HISTORIC AND DESIGN REVIEW COMMISSION

HDRC CASE NO: 2023-029
ADDRESS: 1315 MARCH AVE
LEGAL DESCRIPTION: NCB 11176 BLK LOT 14 & 15
ZONING: I-1, H
CITY COUNCIL DIST.: 3
DISTRICT: Mission Historic District
APPLICANT: Gerardo Noriega/GNA Architecture
OWNER: Joe Sanchez/J SANCHEZ CONTRACTING INC
TYPE OF WORK: Front yard fence, driveway widening, and sliding driveway gate installation
APPLICATION RECEIVED: January 11, 2023
60-DAY REVIEW: Not applicable due to City Council Emergency Orders
CASE MANAGER: Claudia Espinosa

NEW FENCE & GATES
1315 MARCH AVE

COVER SHEET &
ARCHITECTURAL SITE
PLAN
SHEET NO.

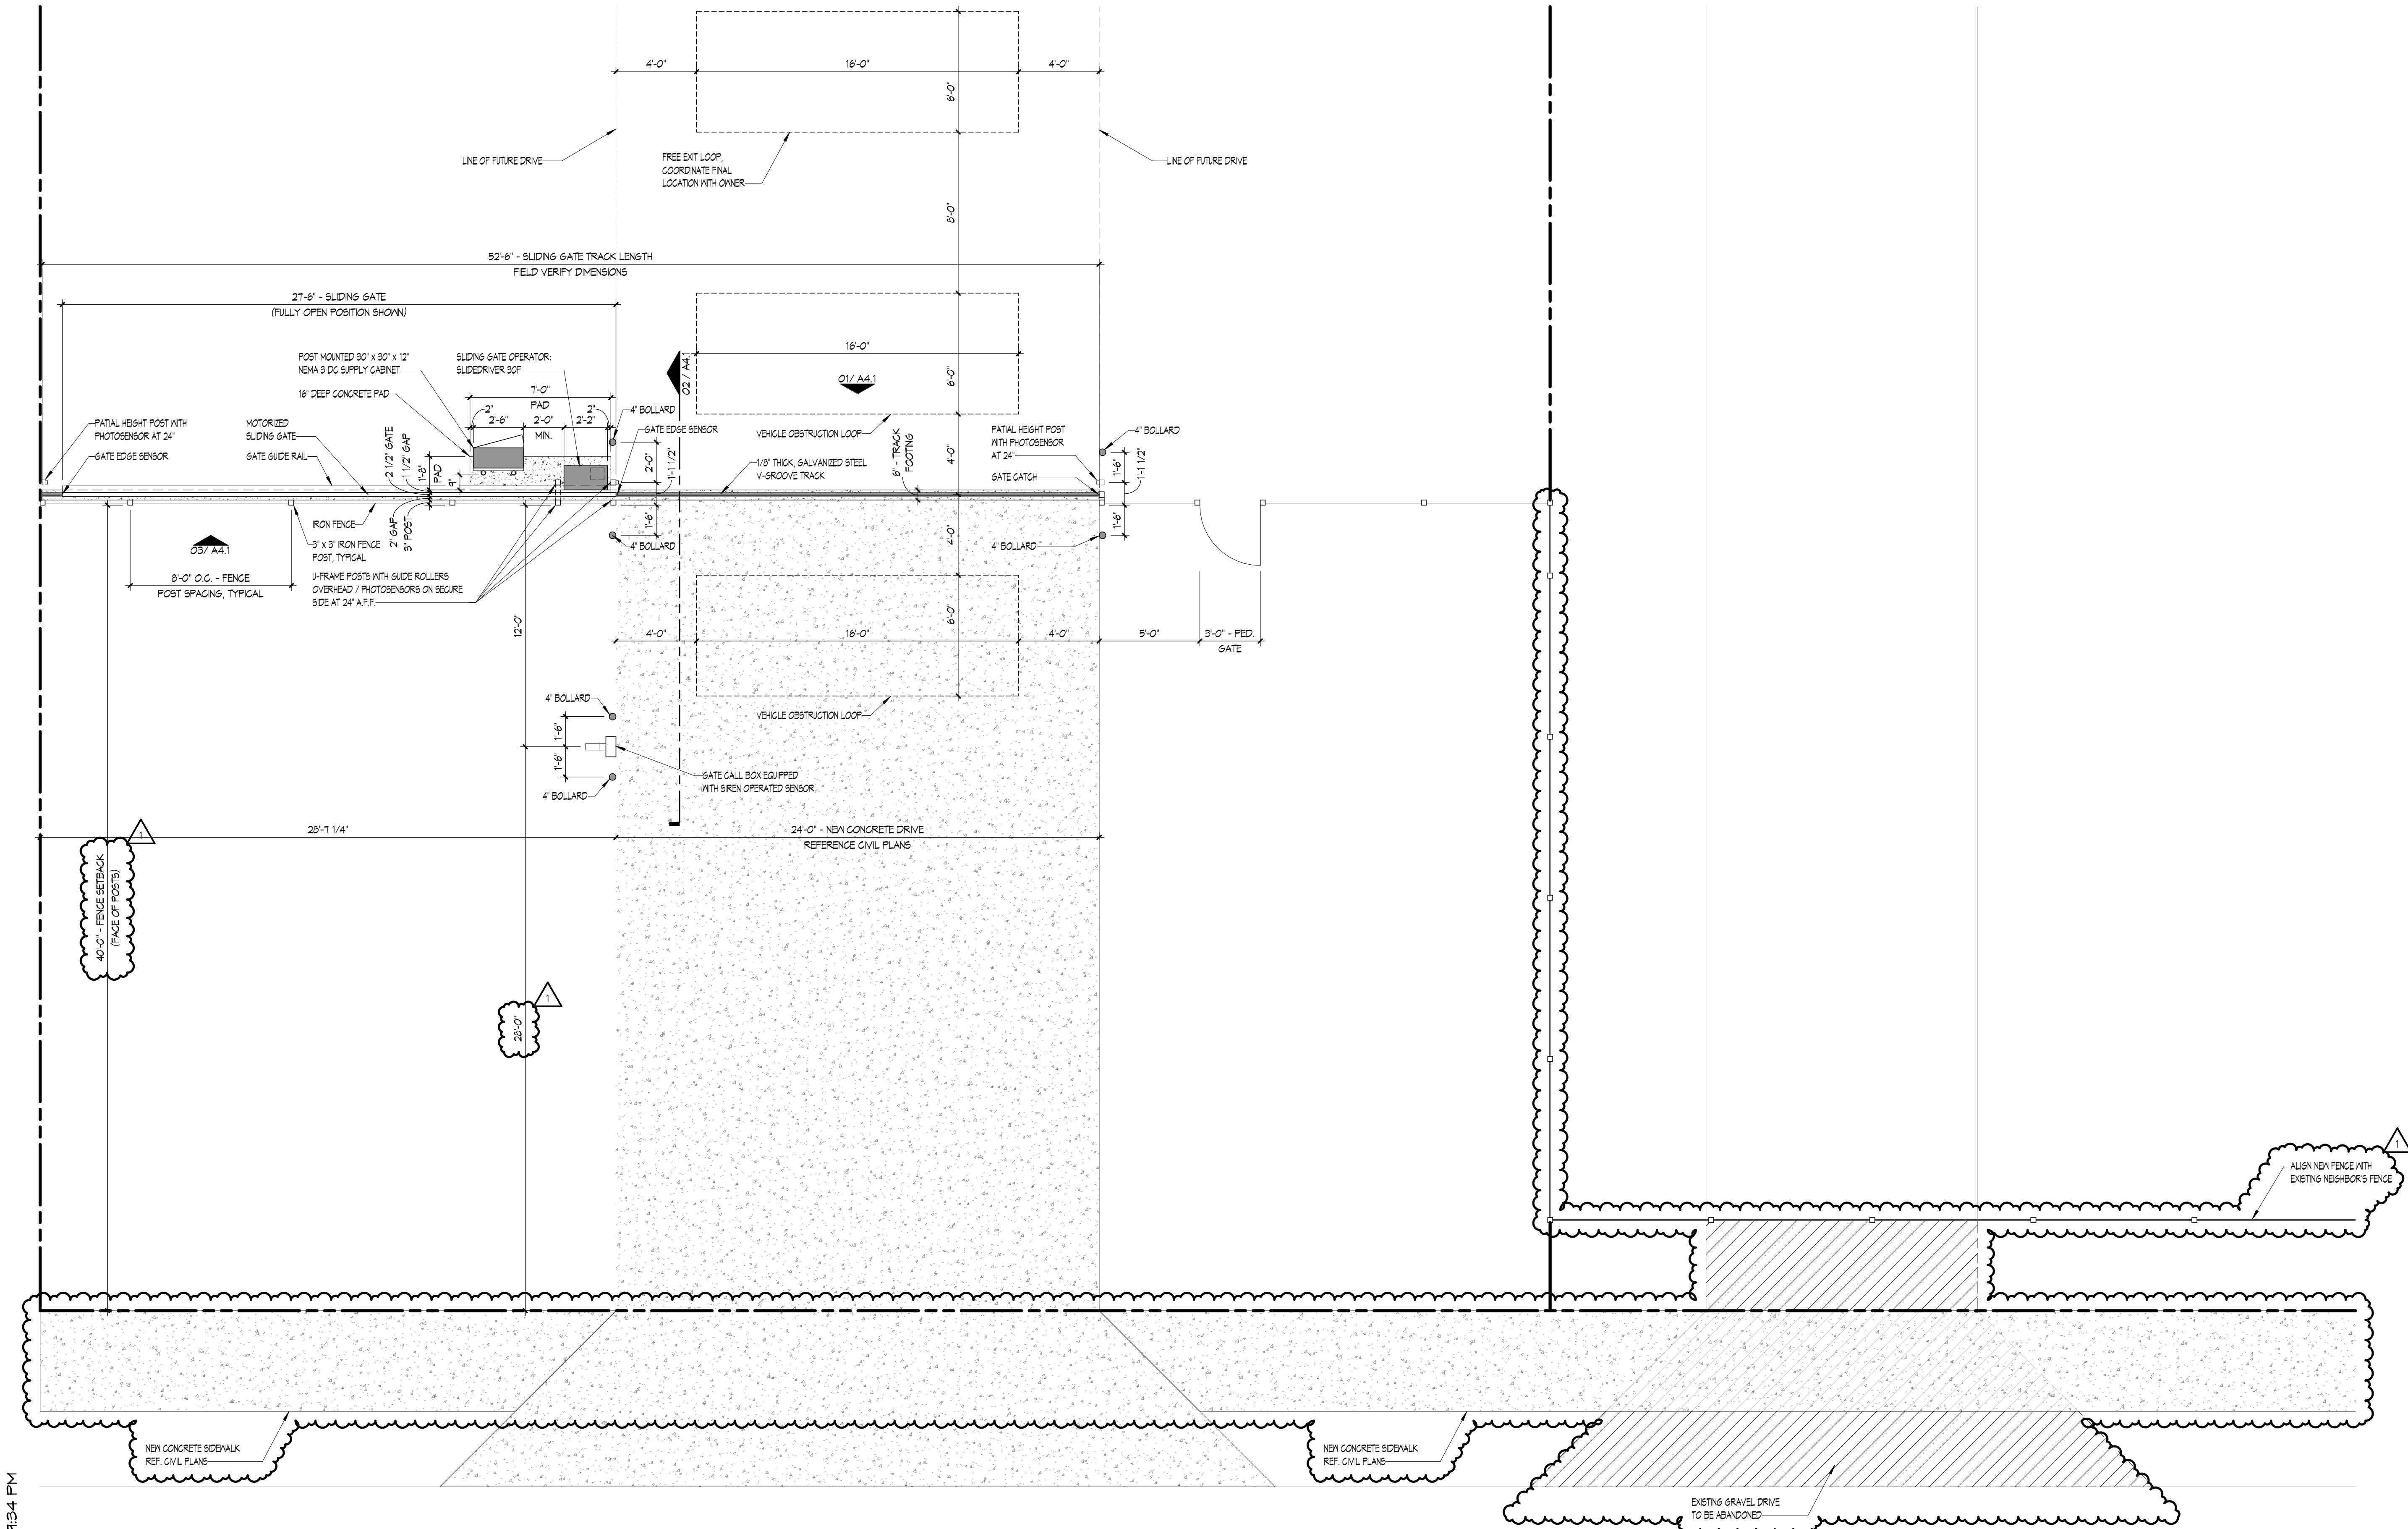
- c. DRIVEWAY REPLACEMENT – The applicant has proposed to remove the existing driveway and install a new twenty-four (24) foot-wide driveway. According to Guidelines for Site Elements, applicants should incorporate a similar driveway configuration—materials, width, and design—to that historically found on the site. Pervious paving surfaces may be considered where replacement is necessary to increase stormwater infiltration. March Avenue features various driveway and site configurations that are atypical for the development pattern found historically within a district. Staff finds that the replacement and widening of the driveway to twenty-four (24) feet is generally appropriate.

- f. SIDEWALK INSTALLATION – The applicant has proposed to install sidewalks on the property line along March Ave. The sidewalks will be 4 feet wide. Guideline 5.C.i for Site Elements states that historic curbing should be retained wherever possible. Historic curbing in San Antonio is typically constructed of concrete with a curved or angular profile. Staff finds the proposal generally appropriate.

Staff recommends approval of item 2, widening of the driveway to a maximum of twenty-four (24) feet in width based on finding c.

Staff recommends approval of item 3, the addition of a sidewalk to the front of the property along March Ave based on finding f.

ELEVATIONS & DETAILS
SHEET NO.

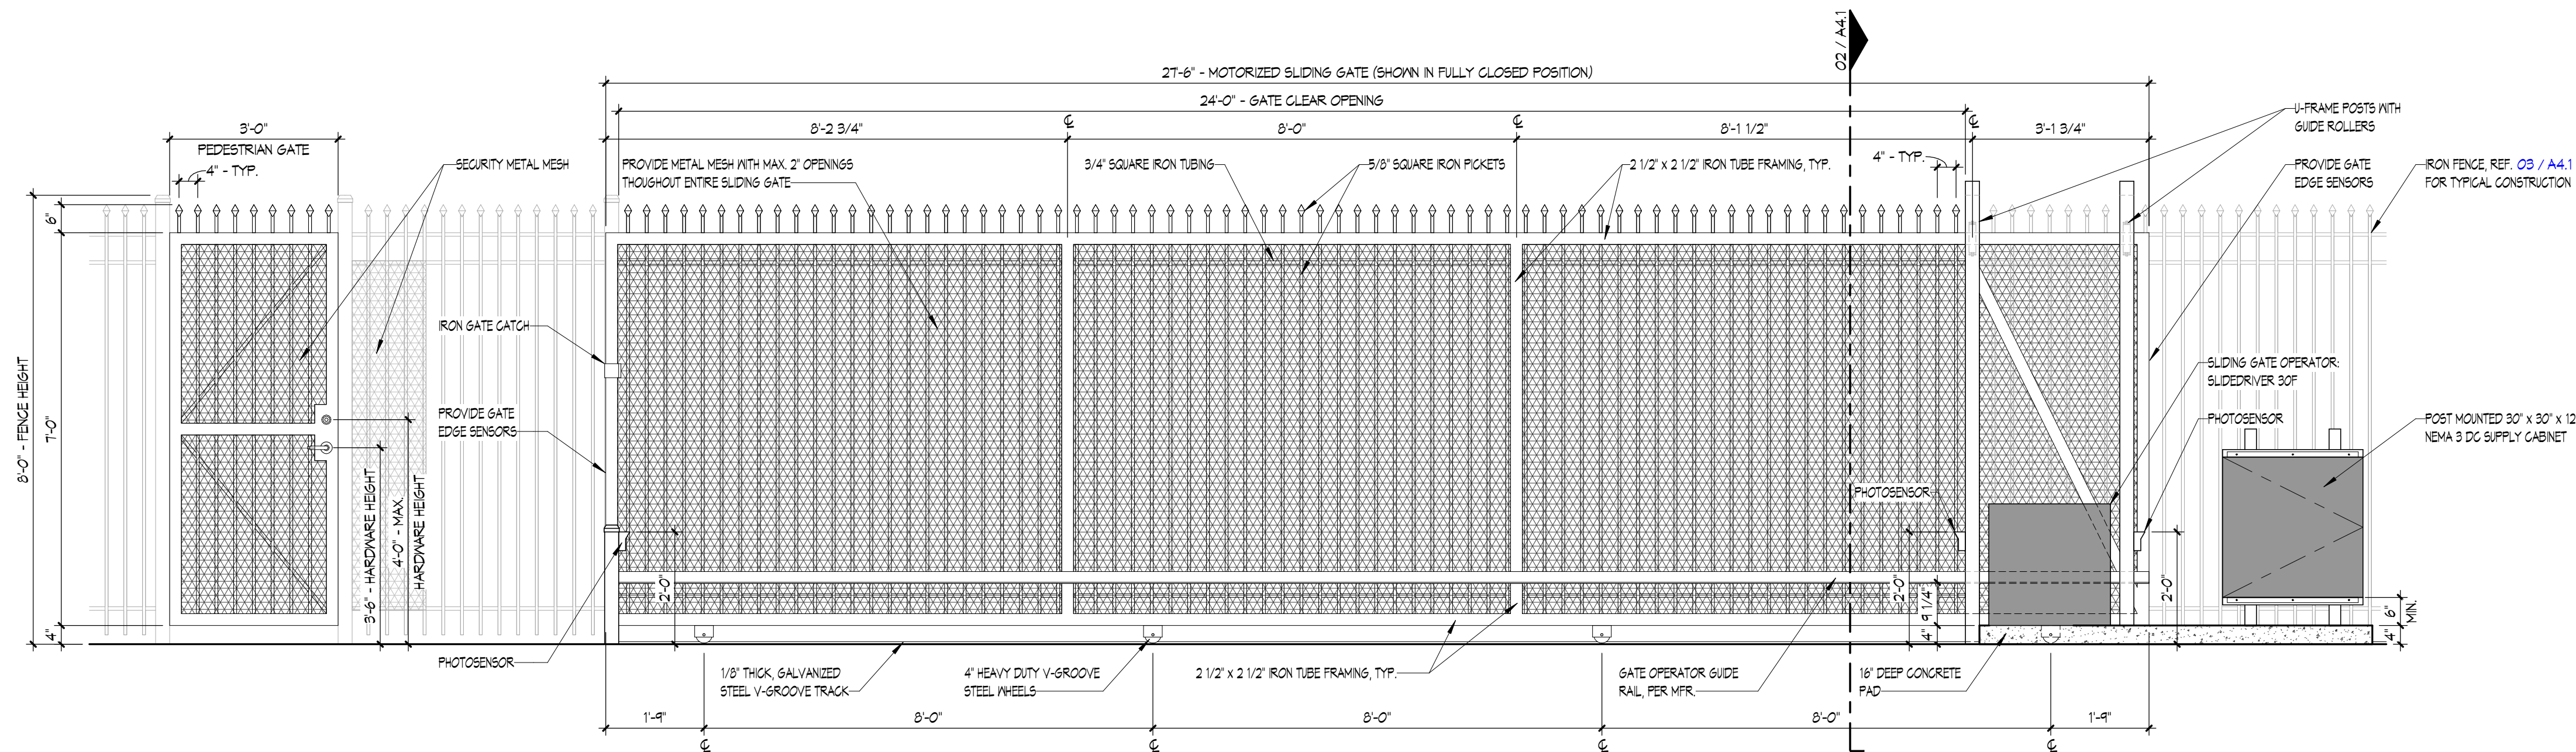
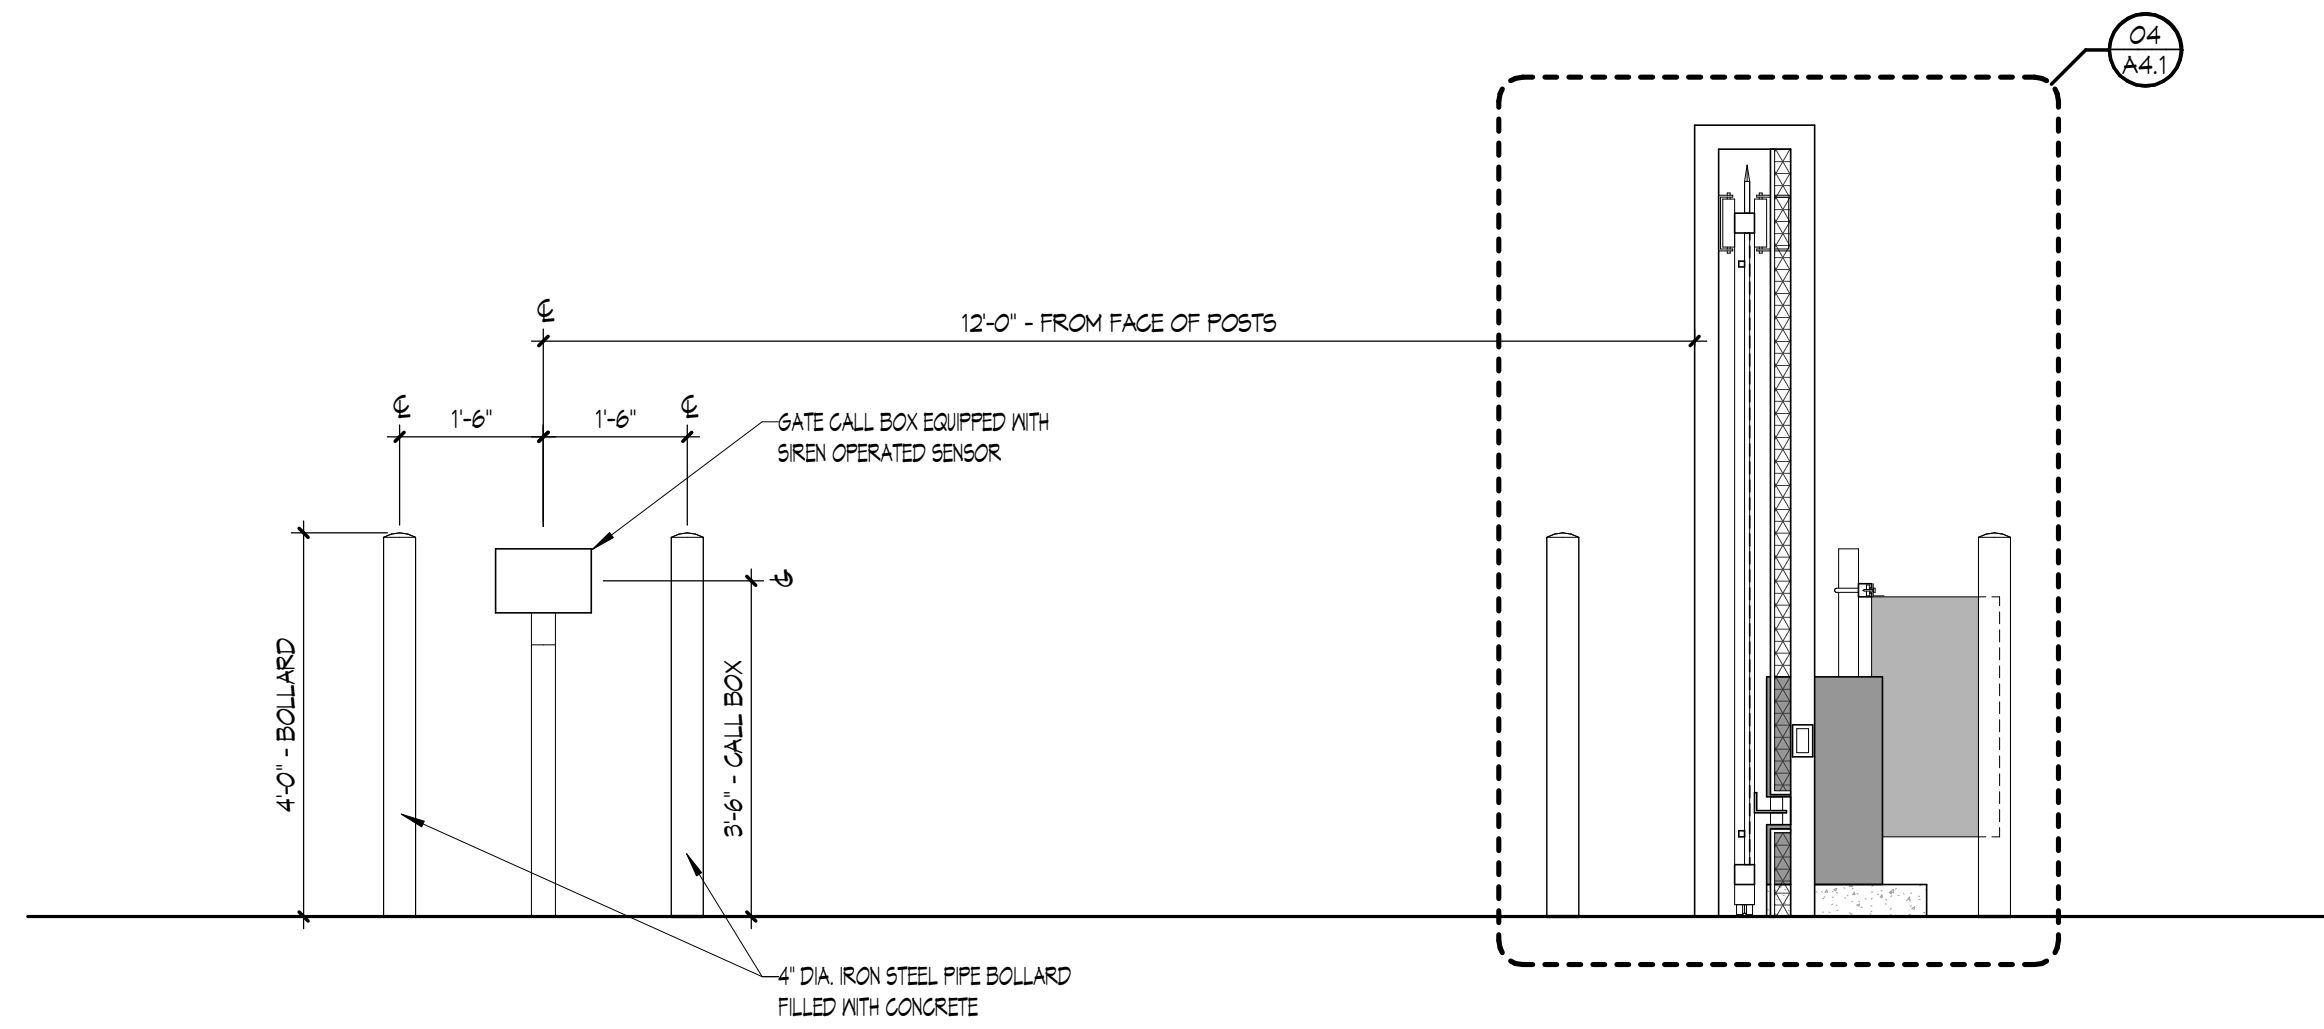
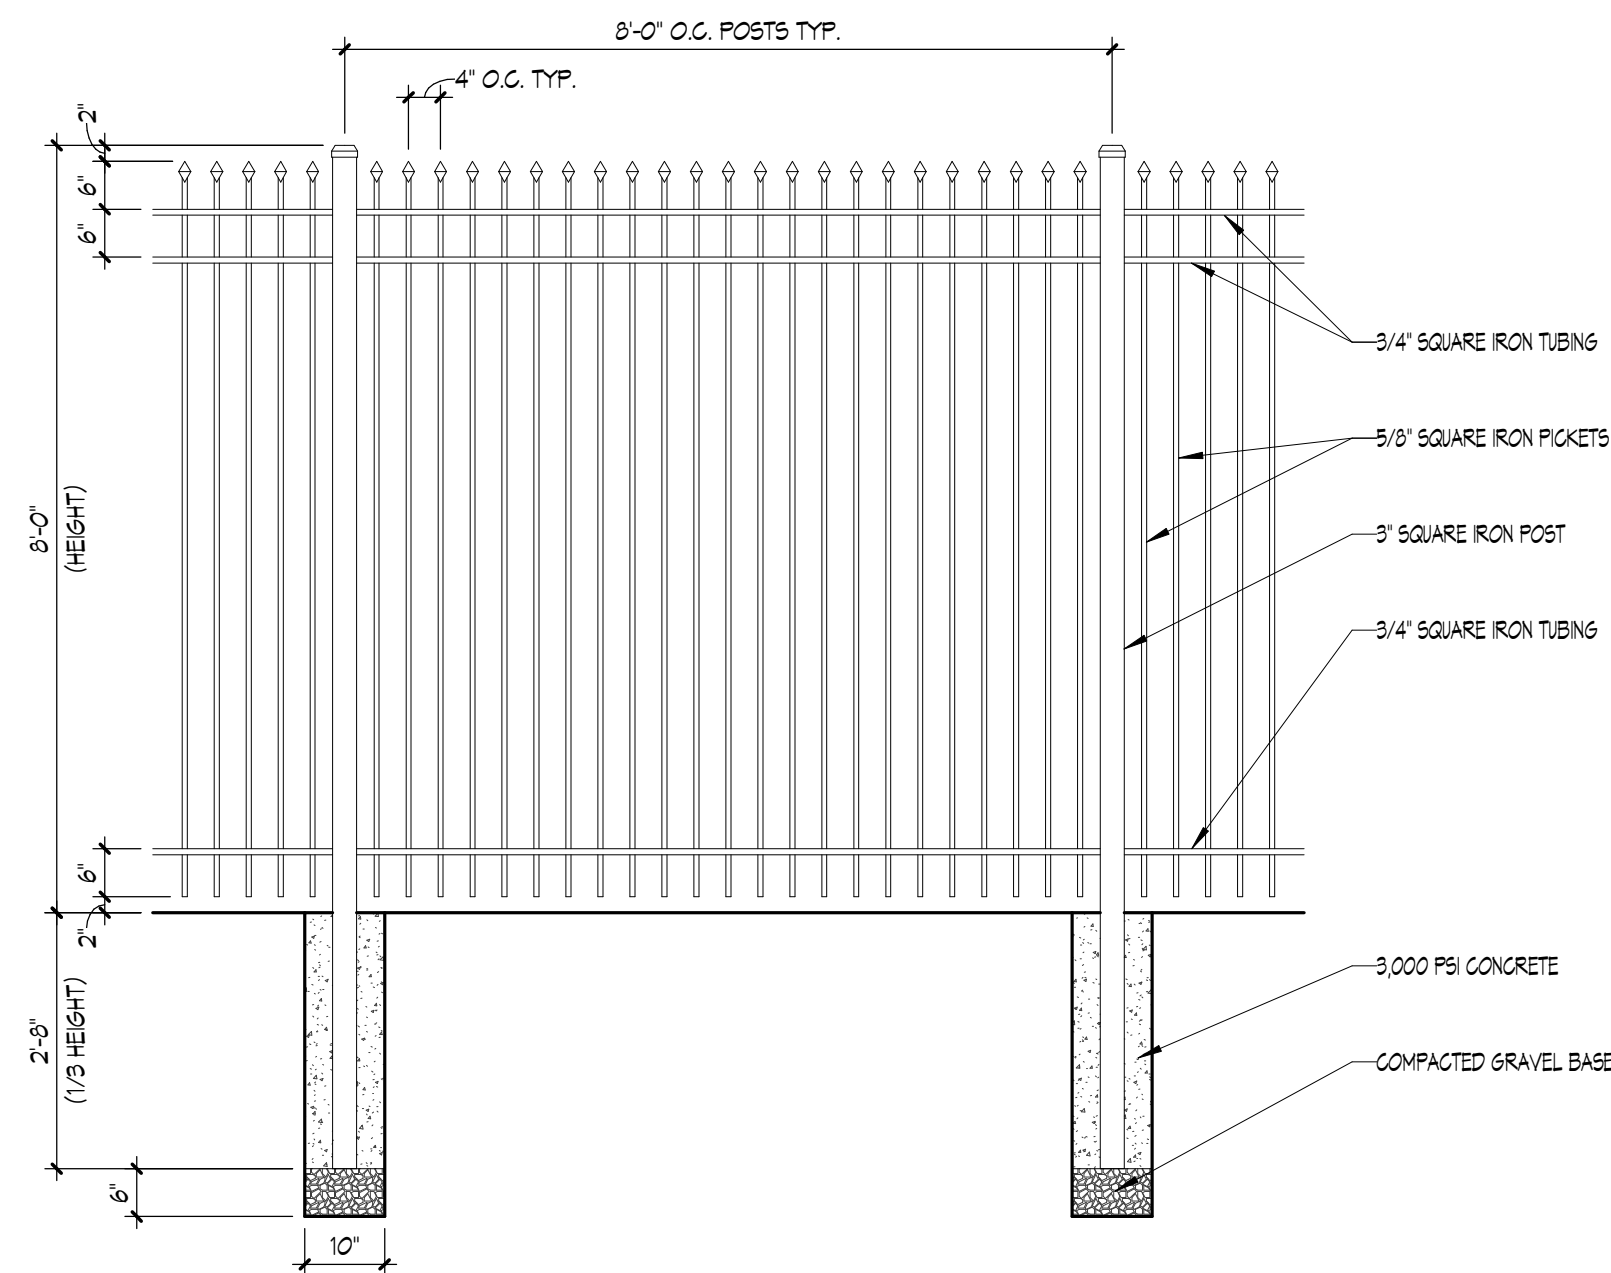
- d. DRIVEWAY GATE INSTALLATION – The applicant has proposed to install a metal sliding driveway gate measuring eight (8) feet in height to meet the existing neighboring fencing meeting at the property line. The Guidelines for Site Elements 2.B.iii, limit the height of new fences and walls within the front yard to a maximum of four feet. The appropriateness of a front yard fence is dependent on conditions within a specific historic district. New front yard fences should not be introduced within historic districts that have not historically had them. If a taller fence or wall existed historically, additional height may be considered. Due to the atypical fencing height in the district, staff finds the request to be appropriate with the maximum height being six (6) feet.

- e. FENCE DESIGN – The applicant has proposed to install a wrought iron fence, matching the fence design in the submitted example photo. Per the Guidelines for Site Elements B. i. new fences and walls should appear similar to those used historically within the district in terms of their scale, transparency, and character. Design of fence should respond to the design and materials of the house or main structure. Staff finds this request should include the a maximum hieght of six (6) feet and the mesh to be only included on the motorized portion of the gate.

Staff recommends approval of item 1, the removal of the existing chain link fence and replace it with a new wrought iron fence with a maximum height of six (6) feet and a motorized sliding gate based on finding d and e. With the stipulation that the metal mesh be only installed on the motorized portion of the wrought iron fence.
